TfNSW reference: REN25/00118/004

**SSD - 78100252, Willavale Battery Energy Storage System - Various Lots, Goulburn Mulwaree Council; Response to Environmental Impact Statement**

**Additional information requested | TfNSW comments**

Figure - Corner of Botany Road / Bumborah Point Road

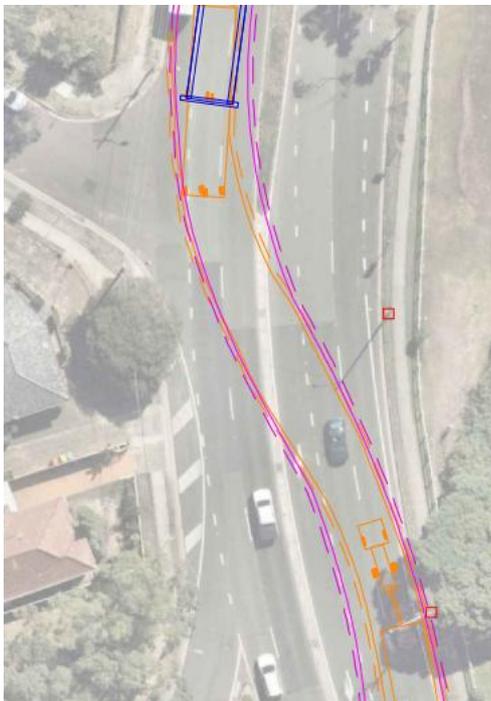
<p><b>Key Issue 2 – The high-risk OSOM route assessment</b></p>	
<p>4.</p>	<p>The proponent has confirmed that high-risk oversized overmass (OSOM) vehicles will be required for transport of the transformer. The following updates to the high-risk oversized overmass route study are required:</p> <ol style="list-style-type: none"> <li>The following locations are identified as traversing state road infrastructure however strategic concept designs have not been provided. Figures of location provided in Appendix B. <ul style="list-style-type: none"> <li>Corner of Botany Road / Bumborah Point Road</li> <li>Median on Bunnerong Road</li> <li>Hume Highway / Wollogorang Road crossover - The project vehicle appears to be tracking off the road surface at the middle crossover between directions at Hume Highway / Wollogorang Road. No hardstand has been proposed for this location</li> </ul> </li> <li>Regarding the following proposed upgrades on the state road network: <ul style="list-style-type: none"> <li>Hume Highway crossover at Parkesbourne - The proponent is to confirm if this is to be removed post completion of the project to reinstate the existing arrangement of the highway crossover. The proponent has identified hardstand to be confirmed for detailed design to the standard of the Hume Highway.</li> <li>Hardstand at Botany Road / Bunnerong Road – proponent notes this will remain in place for the life of the project however this hardstand is located at a highly trafficked intersection on the road network. The proponent is to be clear whether the modifications will be put back to their original condition after the movement has occurred.</li> </ul> </li> <li>Swept paths for pull-over bays/rest areas along high risk OSOM routes (including GPS coordinates) to demonstrate that high risk OSOMs can be physically accommodated for the project (in terms of size, width and accessibility) need to be provided.</li> </ol>

Figure - Proposed Contraflow and Crossover widening - Hume Highway

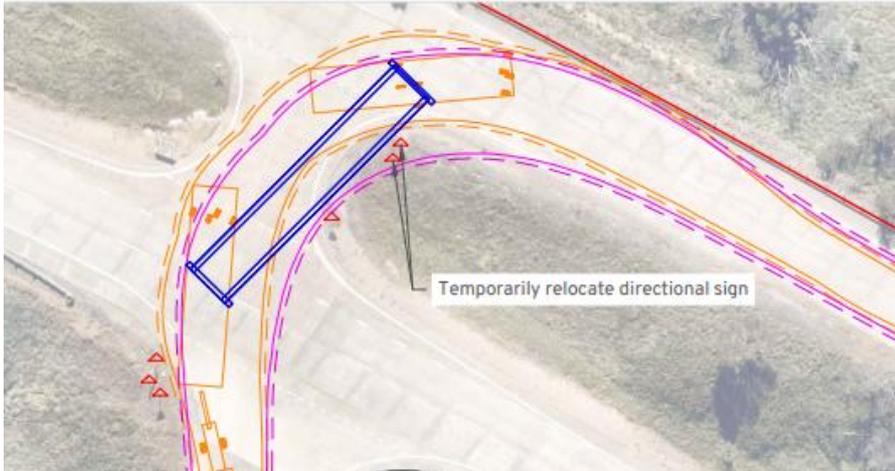
<p>Note - The proponent has proposed contraflow on the Hume Highway. Detail regarding this will need be included in the TMP and TGS will be required. The proponent is to reach out to <a href="mailto:road.manager@transport.nsw.gov.au">road.manager@transport.nsw.gov.au</a> to discuss the potential contraflow and impacts on the Hume Highway.</p>
--	--

Figure – Intersection Hume / Wollongorang Rd

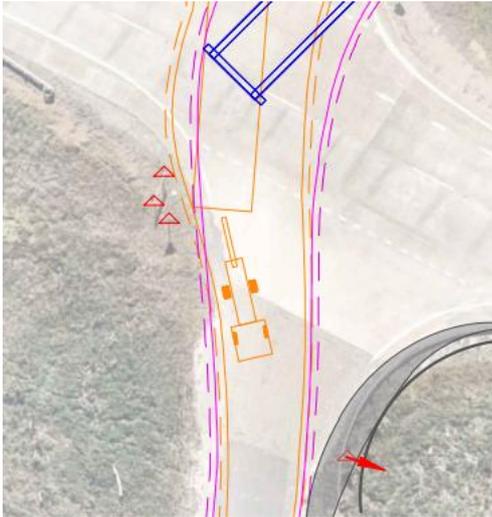
- The storing bay for the right out at the crossover is deficient and would likely need an acceleration bay on the right out.
- Measurements provided on plan 06-SD for the intersection of Hume Highway and Wollongorang Road are incorrect. TfNSW has conducted a site inspection and measured the shoulder to be 2m wide from the edge of the lane to the face of the guardrail, and the through lanes to be only 3.4m wide. Therefore, there is only 5.4m available for the “BAL”, not 6m as shown in Figure 20, page 48, which doesn’t comply with Austroads requirements. The proponent is to reconduct measurements at the site and propose adjustments to ensure compliance with Austroads for any proposed treatments, this could include adjustments to the guardrail and widening of the shoulder.

Considering the issues raised above the proponent is to investigate utilising another connection to the state road or a left in/left out turning restriction and the identification of a suitable turnaround location for vehicles travelling east (for example, at Gunning the Remembrance Drive interchange) along with appropriate upgrades to the intersection, particularly for merging vehicles (for example, an acceleration lane for the left turn out of Wollongorang Road onto the Hume Highway

- A typical cross section diagram will need to be provided for the Hume Highway / Wollongorang Road intersection demonstrating the full extent of drainage

<p>requirements. TfNSW notes that behind the guardrail mentioned in the past point (roughly 1.3m behind) there is a concrete V drain and 3x750mm pipes under the highway, with a headway 3 metres behind the guardrail. The proponent is ensure the design considers these and advise if the footprint of the proposed scope of the design will require augmentation of the drainage infrastructure to achieve compliance with Austroads. t.</p> <ul style="list-style-type: none"> <li>The photographs of the Safe Intersection Sight Distance (SISD) provided in Figure 22 do not demonstrate unobstructed views. The proponent is to confirm if tree trimming is required to achieve the appropriate SISD.</li> </ul>
<p>3.</p>	<p><b>Mitigation Measures</b></p> <p>Further details on all soft mitigation measures proposed to reduce traffic volumes must be clearly stated and quantified in the TIA. Detail and commitments on how these will be enforced must be included in the TIA. For example, section 9.4 discusses shuttle buses; however, it doesn't quantify the number of buses, when these would operate, or how many light vehicles this would reduce traffic volumes by.</p>
